Well Name: POKER LAKE UNIT 22 DTD	Well Location: T24S / R30E / SEC 22 / NWE / 32.209433 / -103.866184	County or Parish/State: EDDY / NM
Well Number: 178H	Type of Well: CONVENTIONAL GAS WELL	Allottee or Tribe Name:
Lease Number: NMNM068905	Unit or CA Name:	Unit or CA Number:
US Well Number: 3001549884	Operator: XTO PERMIAN OPERATING LLC

Sundry ID: 2786001

Type of Action: APD Change

XTO Permian Operating, LLC. respectfully requests approval to make the following changes to the approved APD. Changes to include FTP, LTP, BHL, Casing sizes, Cement, Proposed total Depth, and formation (Pool).

WELL LOCATION AND ACREAGE DEDICATION PLAT

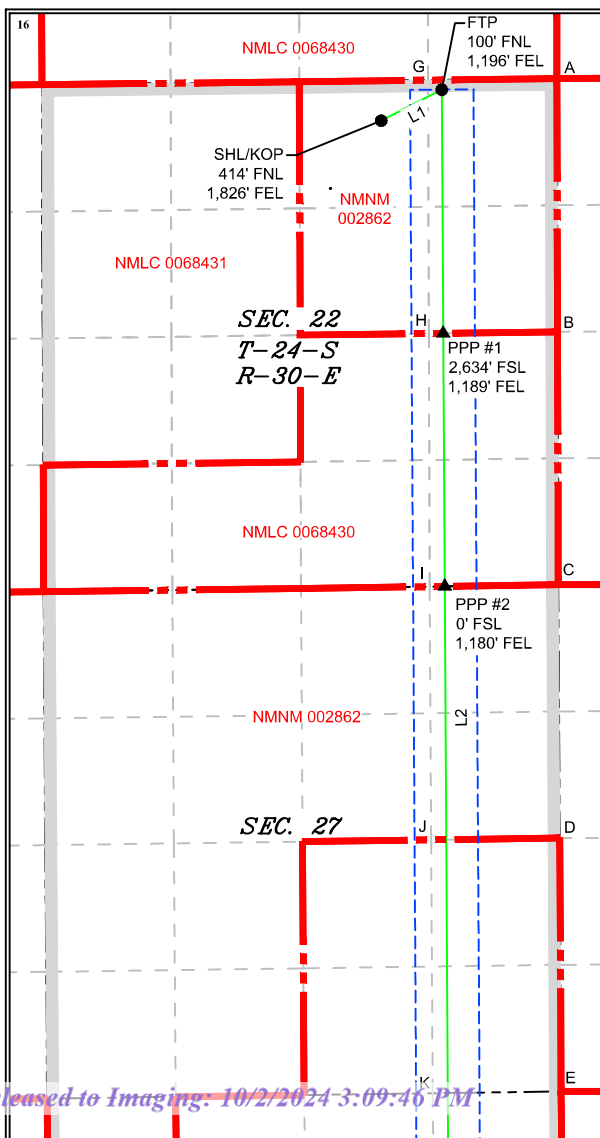
FTP: 100' FSL & 871' FEL OF SECTION 15-T24S-R30E 100' FNL & 1196' FEL OF SECTION 22-T24S-R30E
LTP: 329' FNL & 870' FEL OF SECTION 3-T24S-R30E 2537' FNL & 1195' FEL OF SECTION 34-T24S-R30E
BHL: 199' FNL & 870' FEL OF SECTION 3-T24S-R30E 2627' FNL & 1195' FEL OF SECTION 34-T24S-R30E
Continued on page 3 additional information

UL or lot no.	Section	Township	Range	Lot Idn	Feet from the	North/South line	Feet from the	East/West line	County
B	22	24S	30E		414	NORTH	1,826	EAST	EDDY

UL or lot no.	Section	Township	Range	Lot Idn	Feet from the	North/South line	Feet from the	East/West line	County
H	34	24S	30E		2,627	NORTH	1,195	EAST	EDDY
